2009 Corvette Z06 and ZR1: GM TechLink Article: Oil System Changes - LS7 and LS9

Changes have been made to the dry-sump engine oil system used in the 2009 Corvette

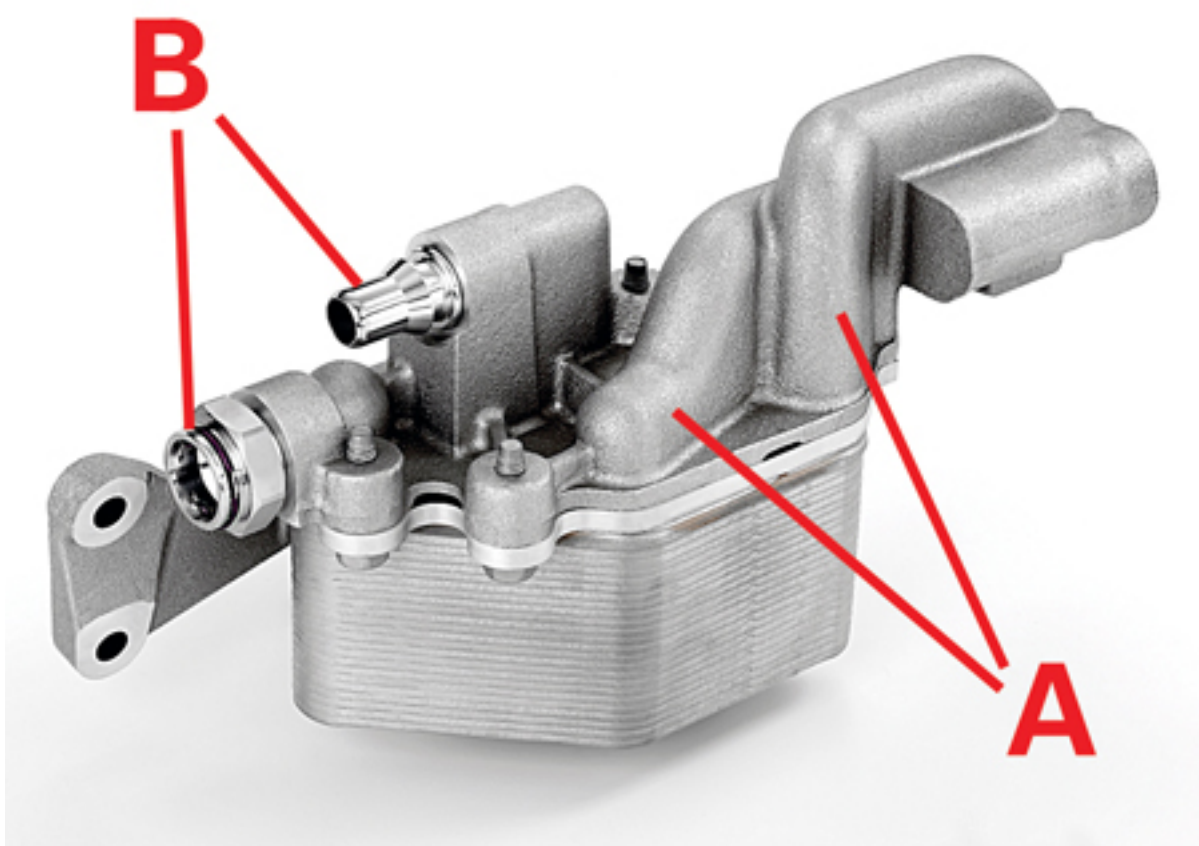
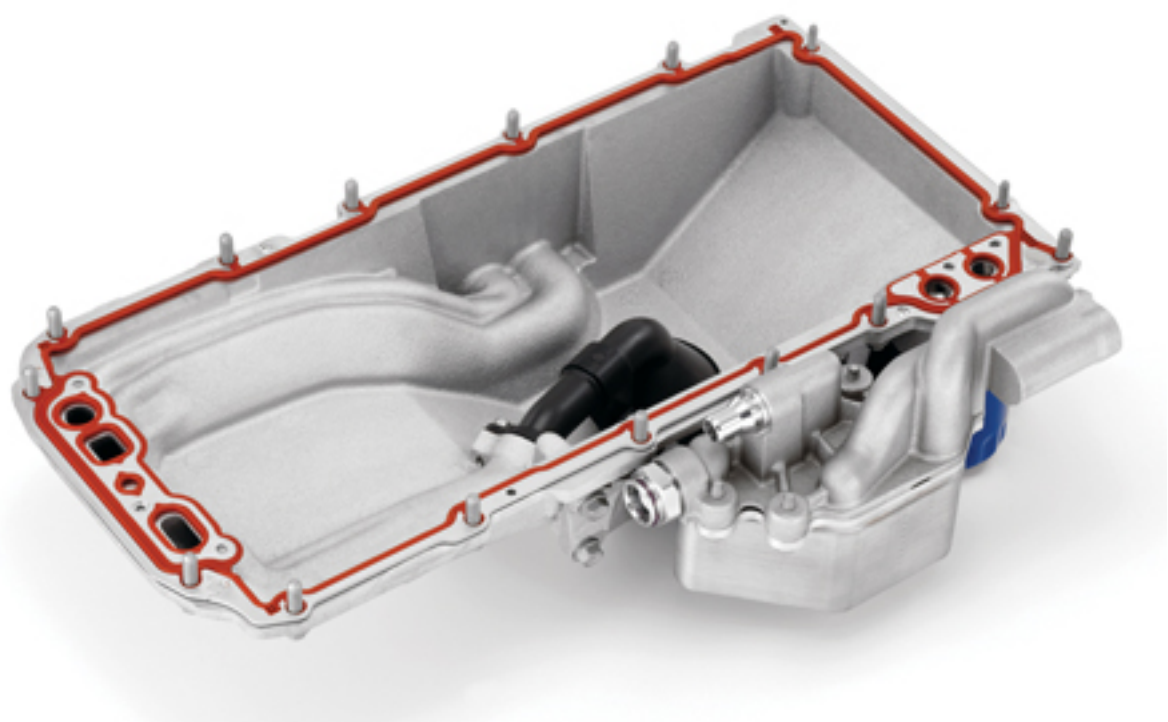
The dry sump system uses a dual gerotor oil pump, one rotor for scavenge and one rotor for supply (fig. 2) . The pump used on the LS9 produces greater volume and higher system oil pressure to provide adequate oil delivery under all conditions.

The LS9 uses eight oil squirters, one per cylinder, for additional lubrication of the pistons and cylinder walls (fig. 3) .

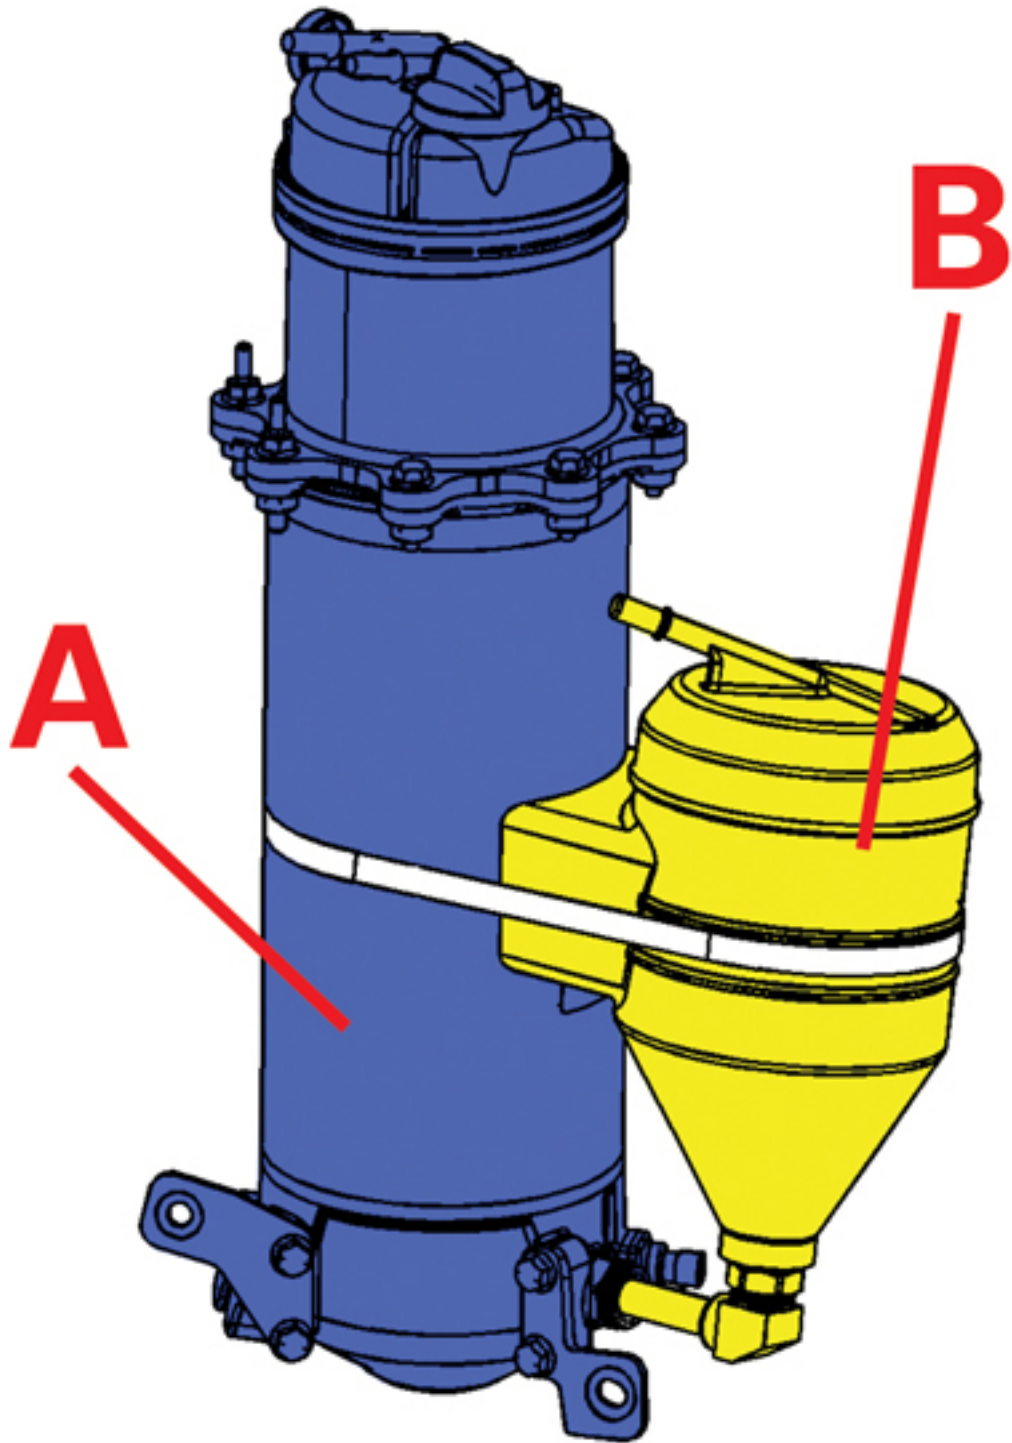
For both engines, the oil reservoir has been redesigned to increase the oil capacity of the system. Under extreme cornering loads such as experienced on a banked race track, extra oil capacity ensures that there is sufficient oil in the reservoir to avoid the ingesting of air due to slosh. A second tank is connected to the main tank by tubing (fig. 6) .

A Original reservoir

B Added capacity

Due to the revised oil reservoir, on both engines the oil capacity is now 10.5 quarts instead of 8.0 quarts, but otherwise the oil change procedure remains the same. Remember, there are two drain plugs in the oil pan. The one on the front of the pan drains the external reservoir and hoses. The other plug near the oil filter drains about a quart of residual oil from the pan. Refer to SI for details.
